## **REMARKS**

The instant application stands objected to and rejected for various formalistic and substantive reasons. The drawings and specification are objected to and claims 1-3 and 34-56 stand rejected as being indefinite and unpatentable over the prior art.

FIG. 4

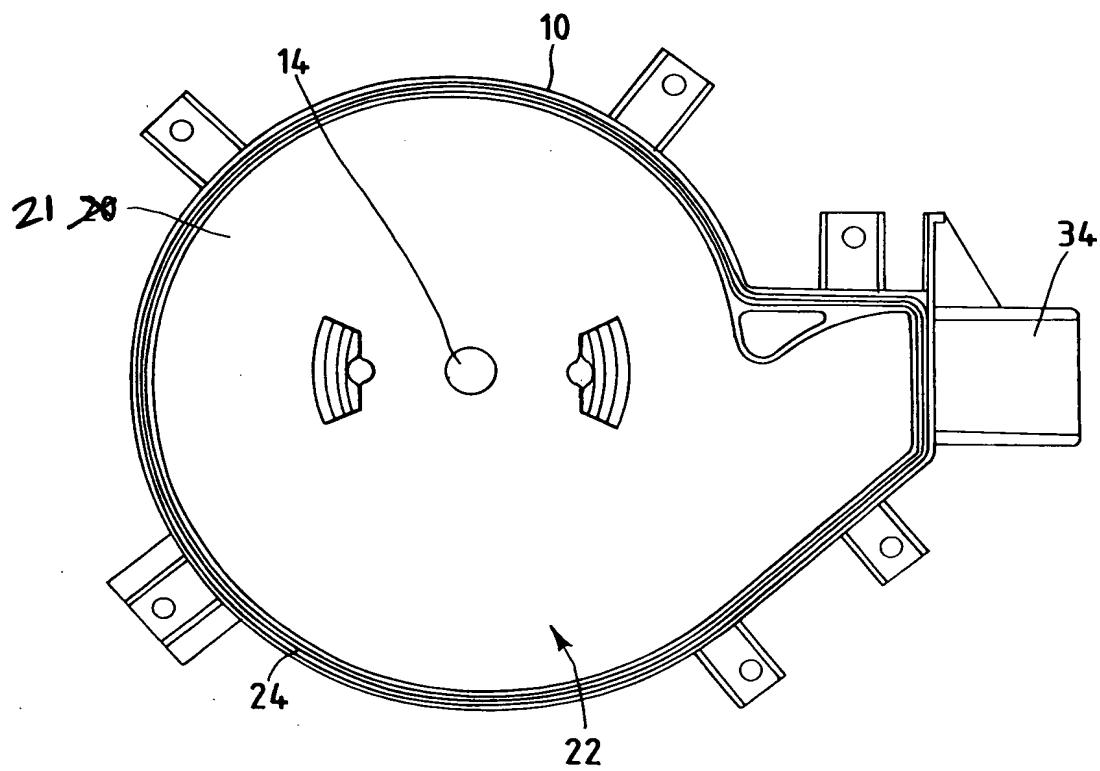
The drawings are objected to because reference character “20” has been used to designate two features of the invention in Figures 4 and 5. The reference character 20 corresponds to the brush holder and the reference character 21 now corresponds to the second side. Attendant corrections have been made to the written disclosure and the drawings. Submitted herewith is a set of amended drawings and request for entry of the same.

FIG. 5

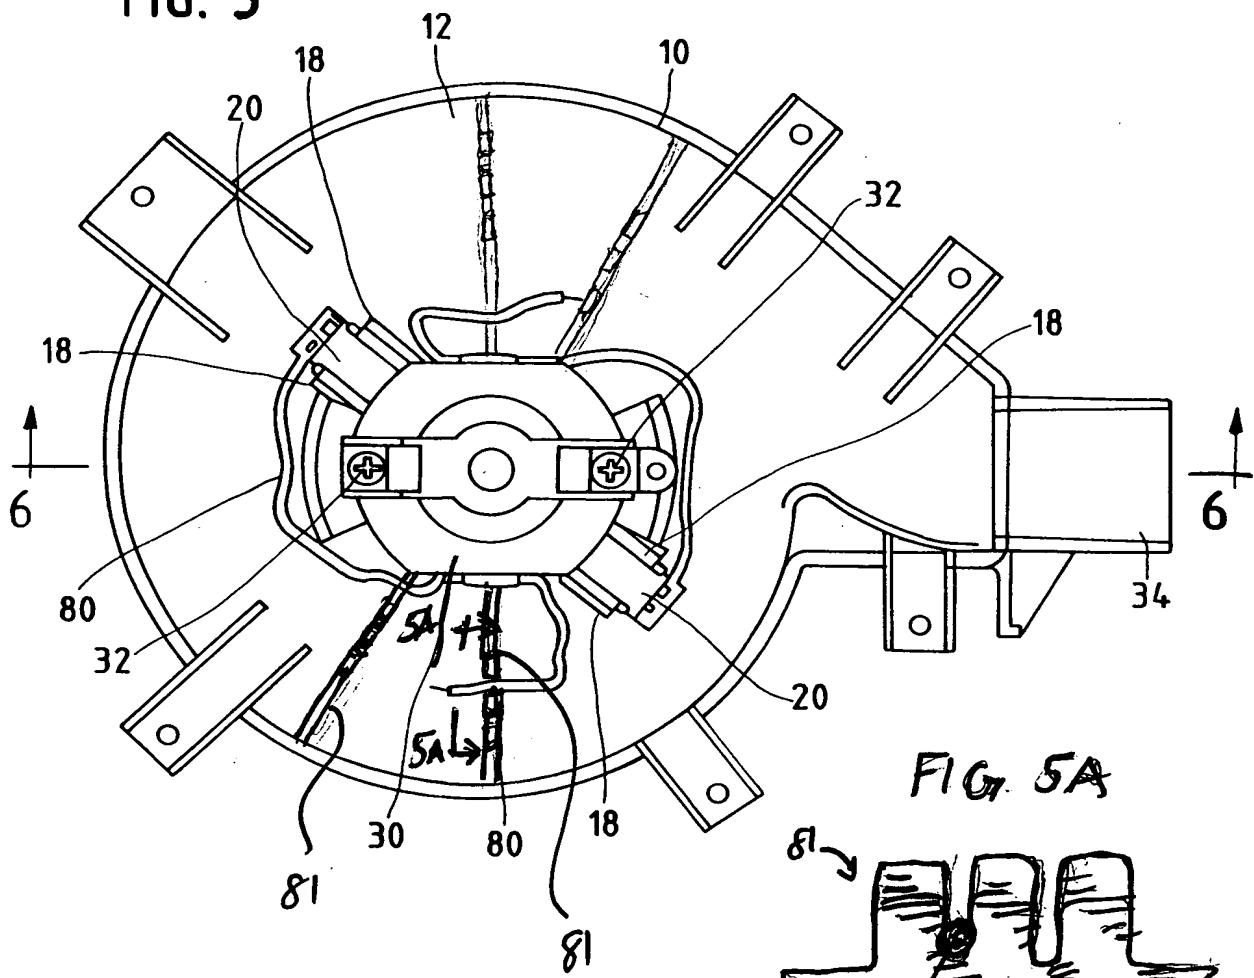
The drawings are also objected to for omitting the “wire guide,” recited by claim 56. Applicant has amended the drawings and written description to reflect the presence of a wire guide (81) holding and retaining wire (80) extending from the motor. Applicant’s submit that the specification, at page 7, supports the “wire guide,” stating that “wire guides (not shown) may be connected to the platform 10. These guides hold and retain in position the insulated electrical wires 80 running from the motor 30.” Further, the wire guide shown in Figures 5 and 5A would have been known to one of ordinary skill in the art at the time of invention.
